SERVICE BULLETIN

M1450: Milwaukee-Eight Equipped Vehicles - Loss of Power or High Engine Braking

M1450

Figure 1. Cam Support Plate Tightening Sequence

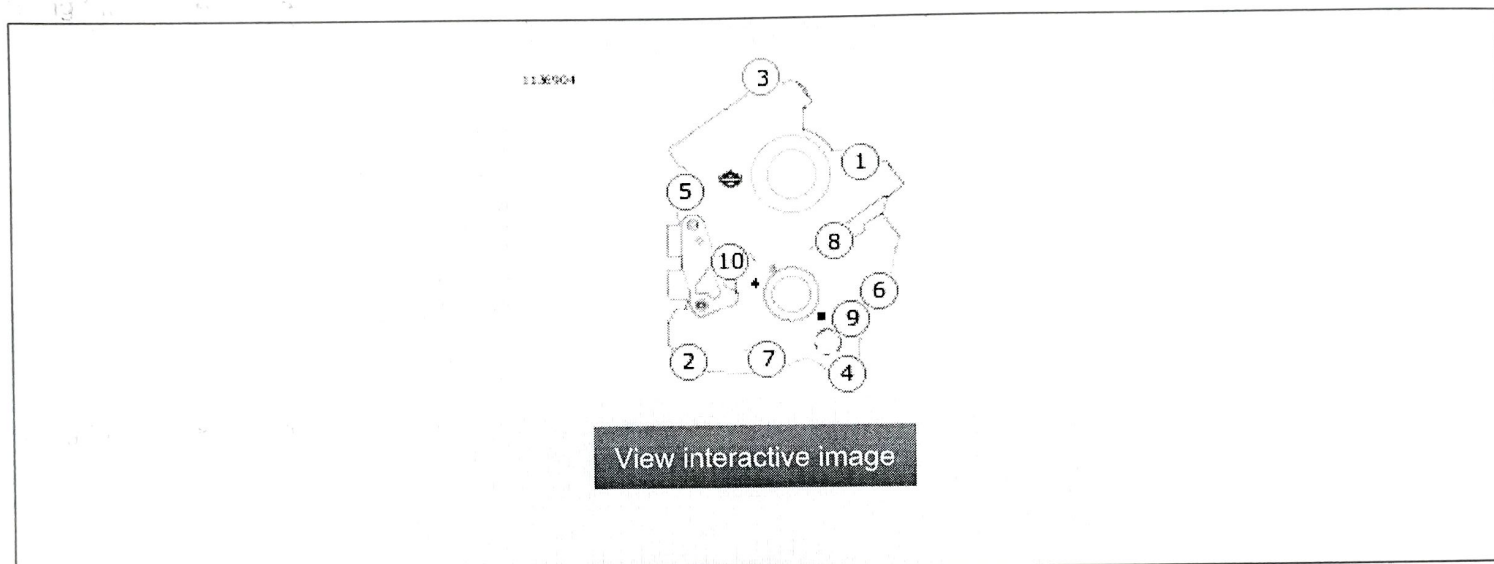
1. Install cam support plate. See the service manual.
2. [Refer to Figure 1.](#) Follow modified tightening sequence.

Torque: 10.4–12.7 N·m (92–112 in-lbs)

- a. Tighten screws 1-6.
- b. Rotate crankshaft 360°.
- c. Tighten screws 7-10.
